ATC1 | Use of Pier Wall for Bridges 405/103E and 405/103

RE: ATC 01 Rev 2: Use of Pier Wall for Bridges 405/103E and 405/103W
I-405, Brickyard to SR 527 Improvement
Design-Build Project

The Washington State Department of Transportation (WSDOT) has reviewed ATC 01, Use of Pier Wall for Bridges 405/103E and 405/103W Rev 2, as submitted on March 31, 2023. WSDOT's determination regarding this ATC is as follows:

The ATC is approved.

10 Figure 1, ATC-01 Conceptual design for Intermediate Pier 3 for Bridge 405/103E, similar to BR04 (now showing
11 existing Culvert penetrating through the Pier Wall).

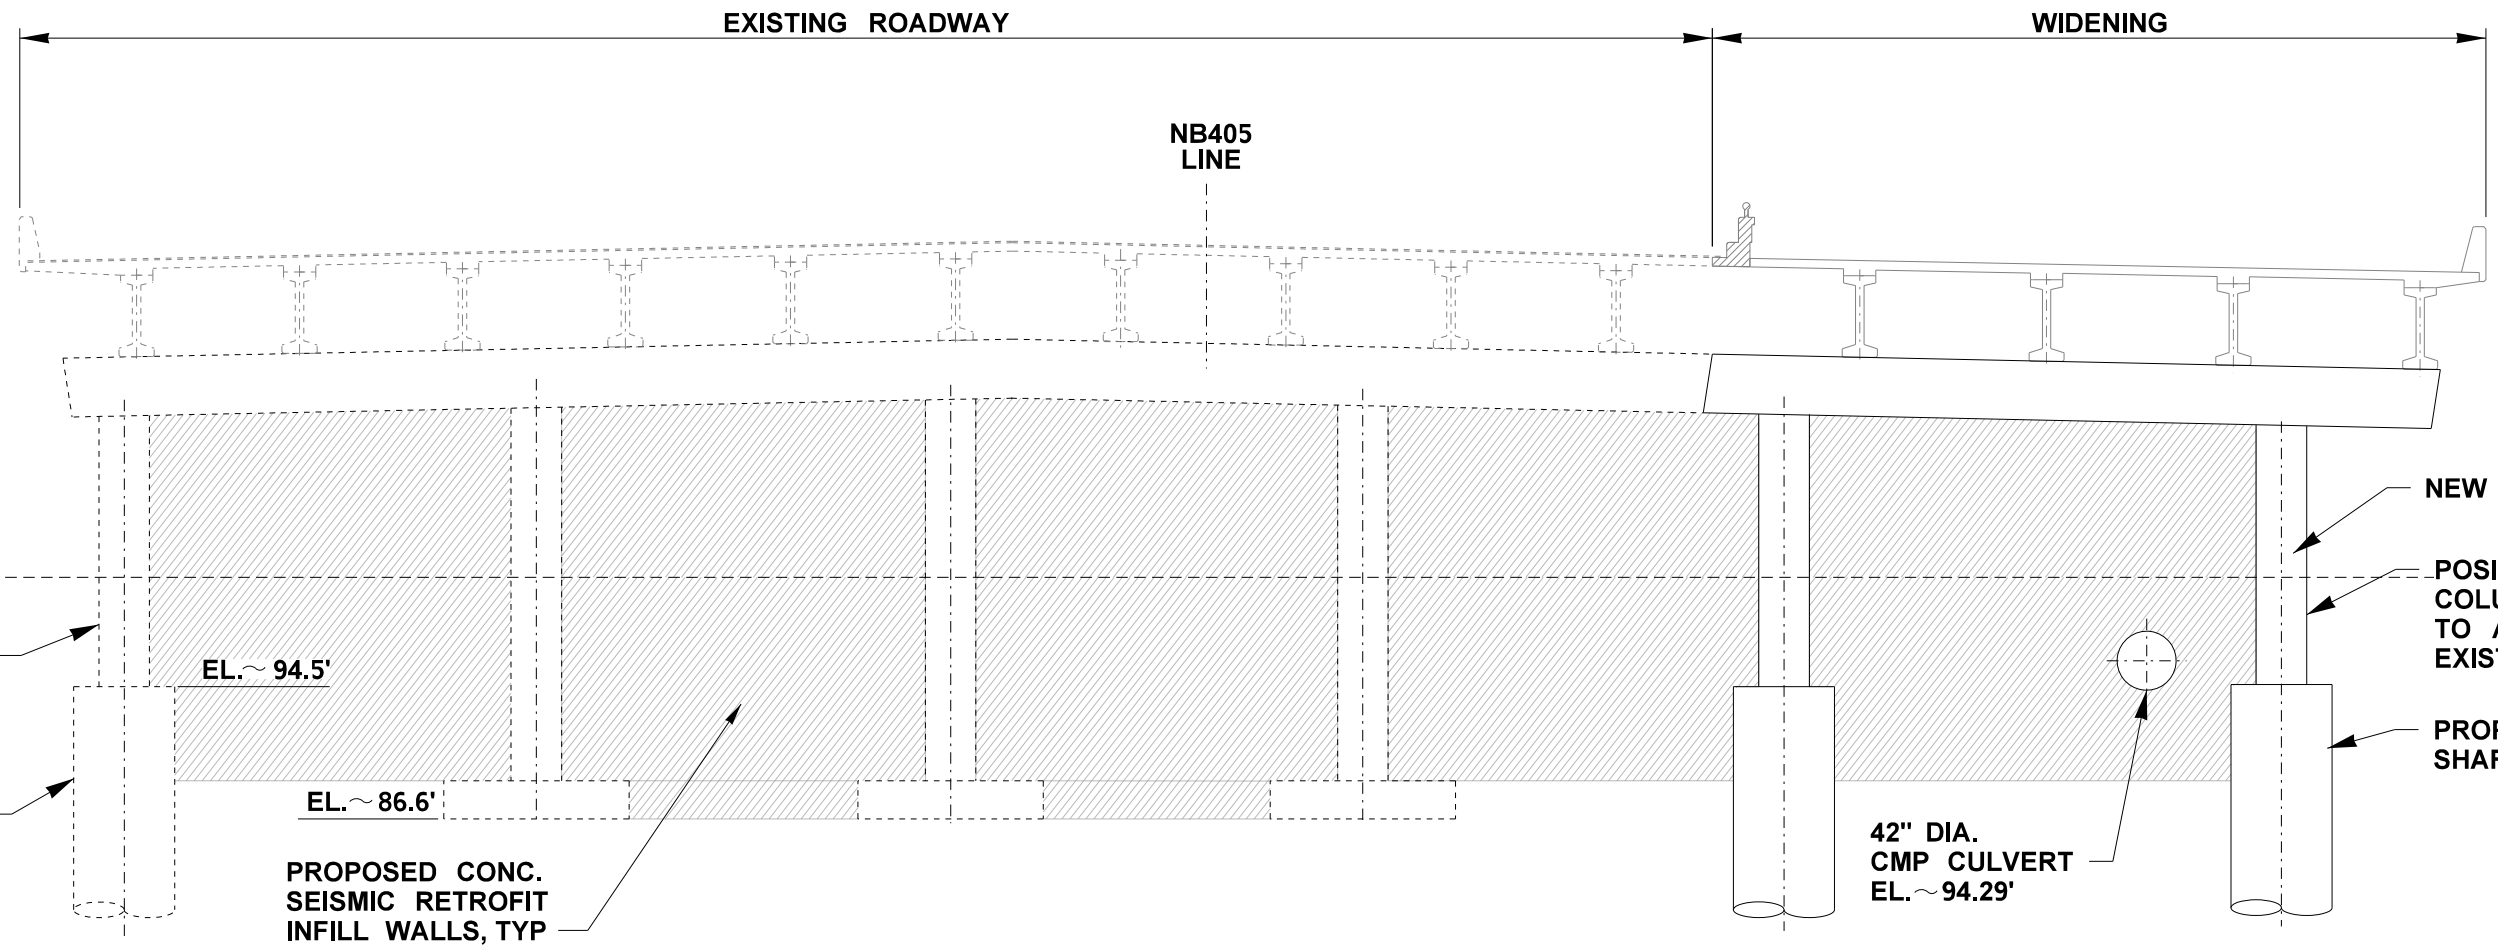
10 The conceptual plan configuration for Bridge 405/103E (Appendix M1, drawing BR-08) proposes
11 using Infill Walls for retrofitting the columns and building two new columns under the widening.
12 Figure 1 presents an extended elevation of the Infill Walls (from BR-08), including the existing South
13 Fork Perry Culvert. It can be observed that the existing culvert is penetrating through the Infill Wall.

15 Steel Jacket Solution: Using steel Jackets for retrofitting the existing columns only provide additional
16 confinement and shear capacity. This solution doesn't help limiting the ductility demand as required
17 in WSDOT BDM Table 4.1-2 for Recovery Bridges. Also, using steel jackets in combination with an
18 Infill Wall is not practical because, holes will be required through the steel casing in order to create a
19 composite action between the column and the Infill Wall. These holes will be detrimental to the
20 confinement (hoop) effectiveness of the steel casing.

6 The Design Builder will protect in place the existing culvert during construction. The design and
7 detailing of the Pier Wall at Bridge 405/103E, Pier 3 will consider the presence of the existing culvert
8 by providing an oversized penetration through the Pier Wall for the pipe culvert.

12 Figure 2, ATC-01 Proposed design for Intermediate Pier 3 for Bridge 405/103E where new columns are
13 eliminated.

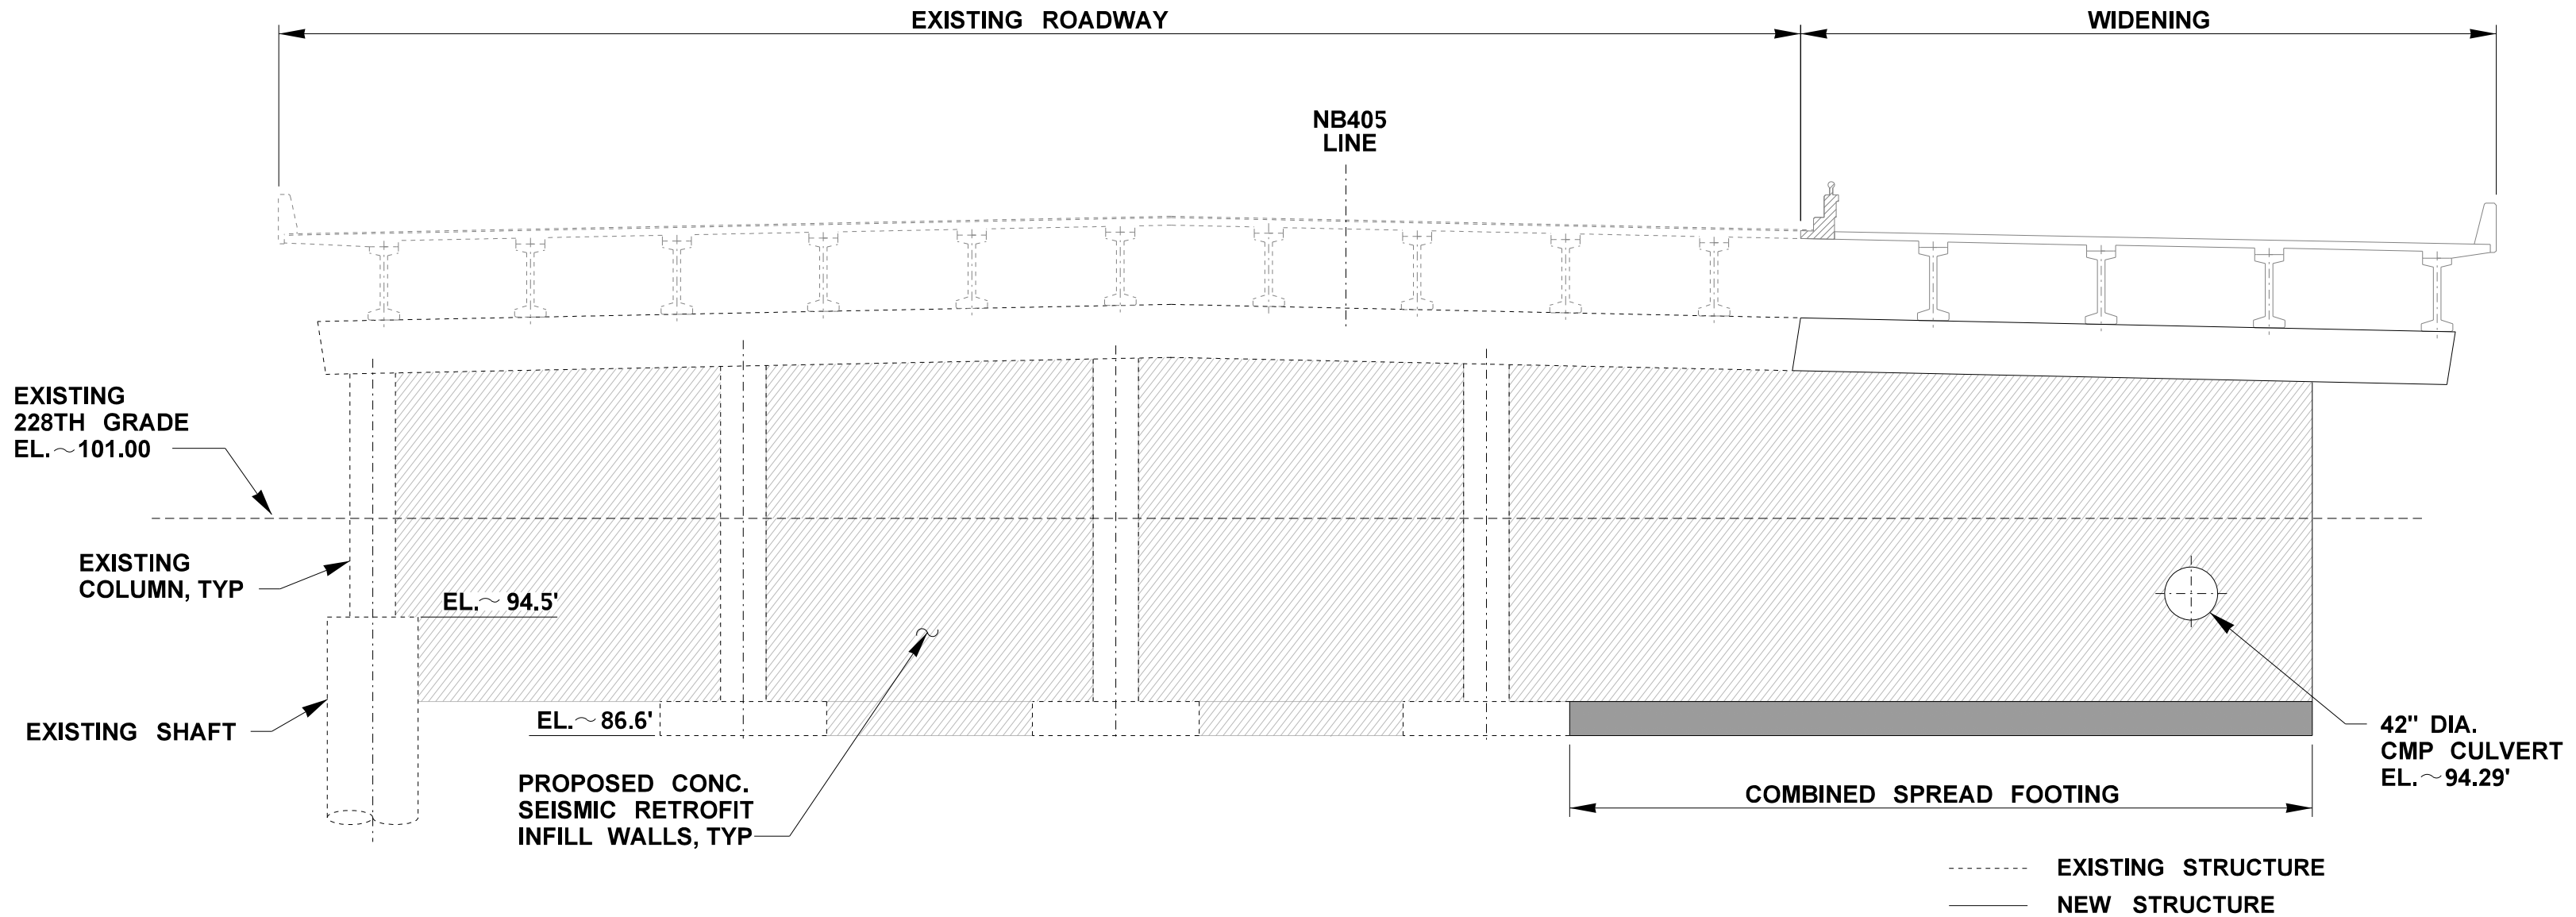
- 23 4) A Pier Wall will be provided for Piers 2 and 3 as shown in Figure 2 (attached).
- 24 5) Girder seat extension and girder stops at abutments are needed.

- 28 1) Bridge 405/103E:
 - 29 a. New columns and drilled shaft under the widening will be eliminated from the
30 design.
 - 31 b. Bolsters will not be provided for the Pier Cap for Piers 2 and 3 due to the
32 presence of the Pier Wall acting as a deep beam in between columns.
- 33 2) Bridge 405/103W:

- a. Steel Jackets for columns built before 1980. The existing columns acting in composite with the new Pier Wall will have enough ductility capacity to withstand the seismic demand.
- b. Bolsters will not be provided for the Pier Cap for Piers 2 and 3 due to the presence of the Pier Wall acting as a deep beam in between columns.
